Work Order ID 69247

DART AEROSPACE LTD HAWKESBURY, ONTARIO, CANADA	
DRAWING NO. D412-664-243	REV. E SHEET 1 OF 4
TITLE CROSSTUBE ASSEMBLY (412 HI AFT)	SCALE NTS

DRAWING NO. D412-664-243	TITLE CROSSTUBE ASSEMBLY (412 HI AFT)	REV. E	DART AEROSPACE LTD ENGINEERING ORDER		D.E.O. NO. D412-664-243-E-1	SHEET NO. SHEET 1 OF 2	SCALE NTS
DRAWN	CHECKED	MFG. APPR.	APPROVED		DE APPR.		
DATE 11.03.31	DATE 11/03.31	DATE 11.03.31	DATE 11/03.31		DATE 11.03.31

REMOVED ABRASION STRIP IN FAVOR OF A THIN LAYER OF PROSEAL 890.

**D412-664-243
ASSEMBLY DETAIL**

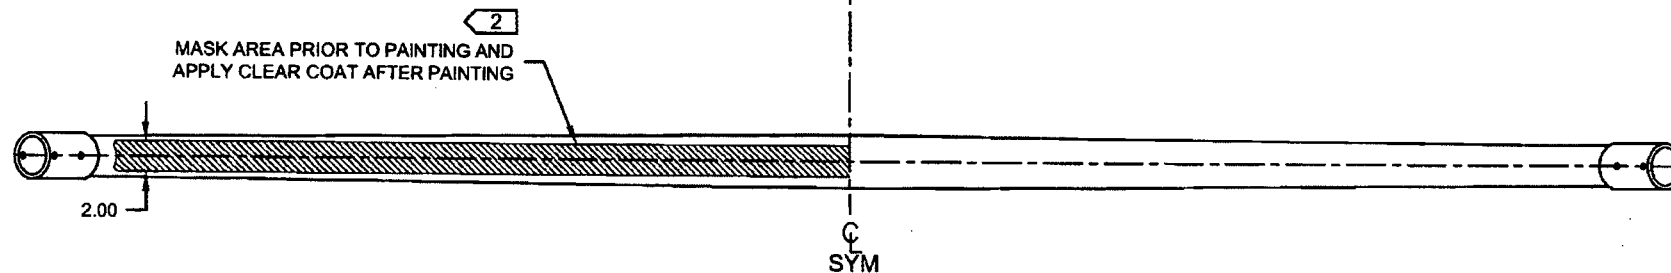
IS:

D3189-1 CHAFING SHIELD (1, INSTALLED OVER PROSEAL 890)
MS21920-28 CLAMP, 2X
2 PL

WAS:

D2856-600-1009 ABRASION STRIP
D3189-1 CHAFING SHIELD (1, INSTALLED OVER ABRASION STRIP)
MS21920-28 CLAMP, 2X
2 PL
